February 21, 2025

Re: **Chehalem Valley Winery Tasting Room (PWS #95731)**
2023 Well #1 ([L151862](#), YAMH59420) and 5,300-gallon potable tank
Final Approval (PR #28-2024)

Water system overview

LOCATION OF WELL

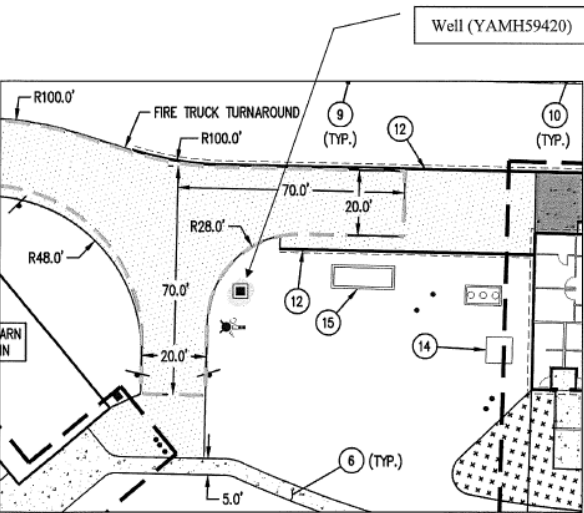
Additional Notes/Comments/Requests: Well was drilled without going through plan review. This single well will serve a new TNC system called Chehalem Winery Tasting Room. The submitted plans use the yellow square symbol shown below for the wellhead.

50- and 100-ft diameter radii:

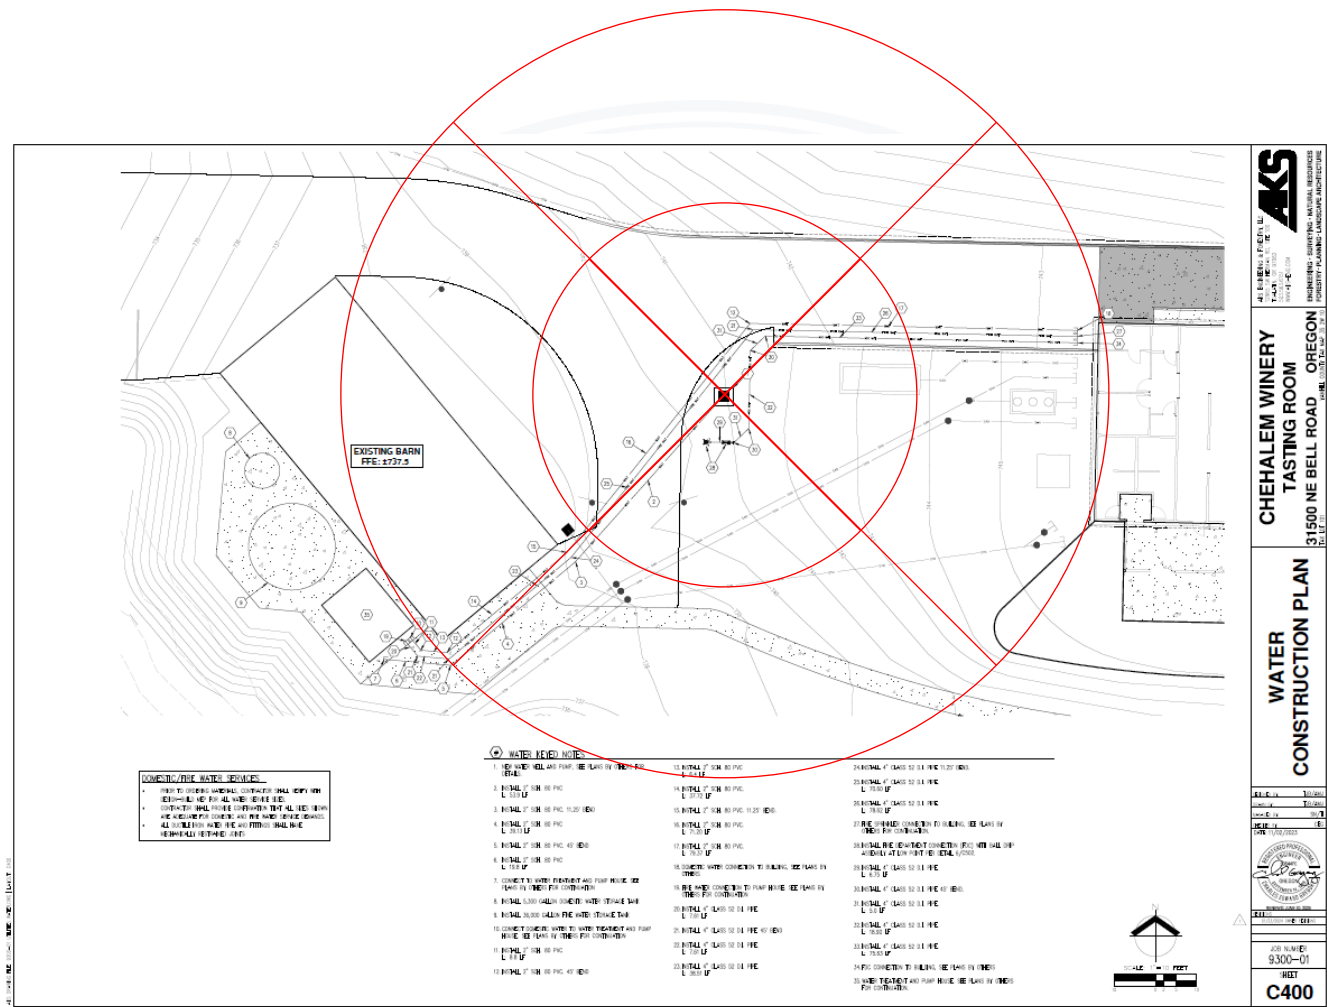
Approximate 50- and 100-ft radii circles shown in red below (the diameters are based on the middle-sized 48-ft diameter radius of the Fire Truck turnaround).

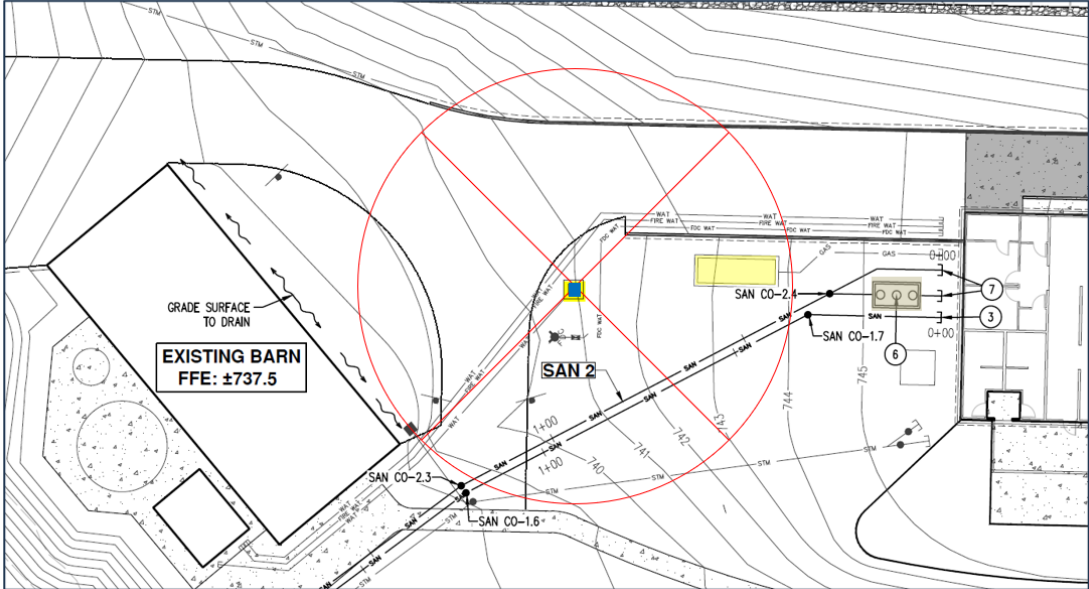
Approximate 50-ft radius circle is drawn around the wellhead below showing the septic tank (shaded in brown) appears to be outside this setback distance. A propane tank (shaded in yellow) is within the 50-ft setback.

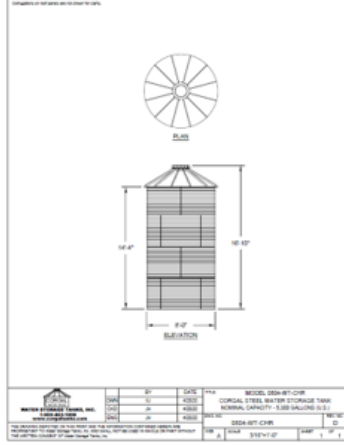
Describe situation that conflicts with the standard. The only access to the inside of the manufactured 5,300-gallon CorGal potable water storage tank (manufactured by Water Storage Tanks, Inc.) is on the roof. The tank has an exterior ladder, however, the tank does not have a permanently affixed internal ladder.

Describe why meeting the standard is highly burdensome or impractical. The manufactured tank is relatively small and has an internal liner system (as shown), which makes affixing an internal ladder difficult and may void the tank manufacturer's warranty as this is not a standard construction feature for this style of tank. The tank has an internal liner and a ladder is unable to attach to the walls without damaging the liner.

Describe proposed alternate measure that provide adequate protection to public health and safety. Entry to the tank will be treated as a confined space entry and a stepladder (with padded feet to protect the NSF-61 interior liner from damage) will be lowered into the tank when entry is needed per the manufacturer's instructions as shown below.

☒ Plan Review Coordinator's notes: Proposed mitigation is an acceptable alternative.

Comments: Reservoir hatch must remain locked to address safety issue.

The hatch does lock... and the ladder has a security cover that can lock as well, I will get by there and take pictures later today.
